Department of Energy
Washington, D.C. 20585

Re: Proposed Rulemaking on the Storage
and Disposal of Nuclear Waste (Waste
Confidence Rulemaking), NRC Docket
No. PR-50,51 (44 FR 61372)

Reexamination of technical documents used in preparing the United States Department of Energy's Statement of Position (DOE PS) in the above-entitled proceeding just has revealed that DOE PS, Figure II-1 (at page II-12) is incorrect. See also DOE CS at II-72. Apparently, a preliminary author's draft was used inadvertently in the Department's Position Statement. Accordingly, the attached erratum provides a figure, taken from the paper by J. W. Voss cited as the source for the figure, DOE PS, Ref. II-25, that should be substituted for that now appearing in the Position Statement.

FIGURE II-1 HAZARD INDEX OF URANIUM ORE AND VOLUME-EQUIVALENT OF SPENT NUCLEAR FUEL REPOSITORY

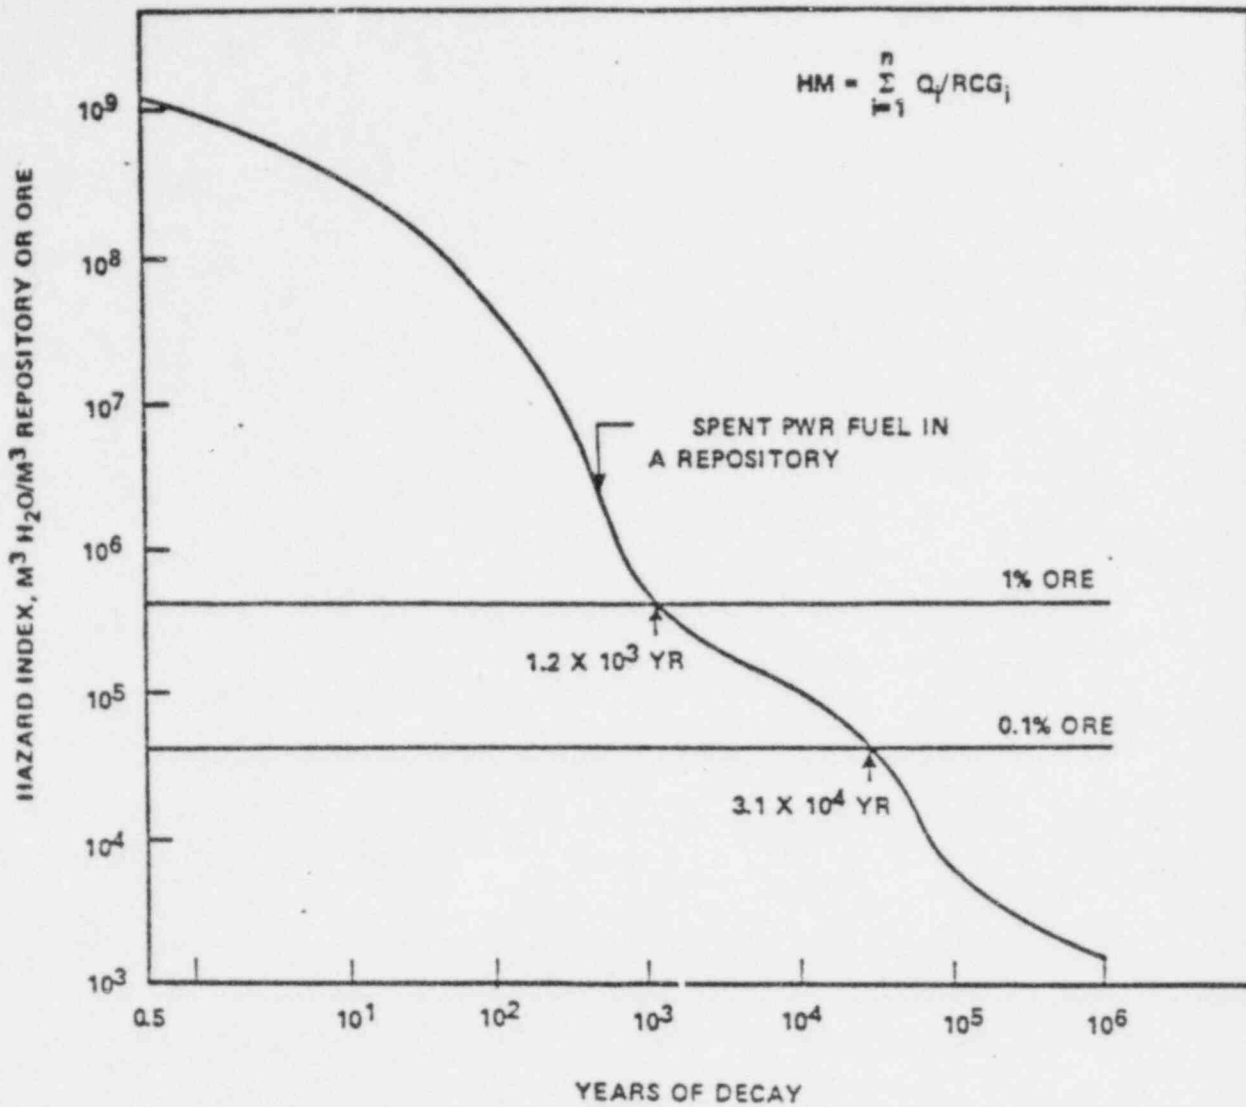
The impact of this correction is to provide a further degree of conservatism in supporting the containment and isolation objectives proposed by the Department. The incorrect figure shows that spent nuclear fuel in a repository would decay to a concentration of a 1% uranium ore deposit in 3,200 years. The correct figure indicates that this hazard actually will be reached in 1,200 years. Similarly, it shows that a period of 31,000 years will be required to reach a hazard measure equivalent to 0.1% ore rather than the 36,000 years originally shown. Because of this correction, the 3,200-year figure that now appears in the Department's Cross-Statement, DOE CS at II-72, also should be changed to 1,200 years.
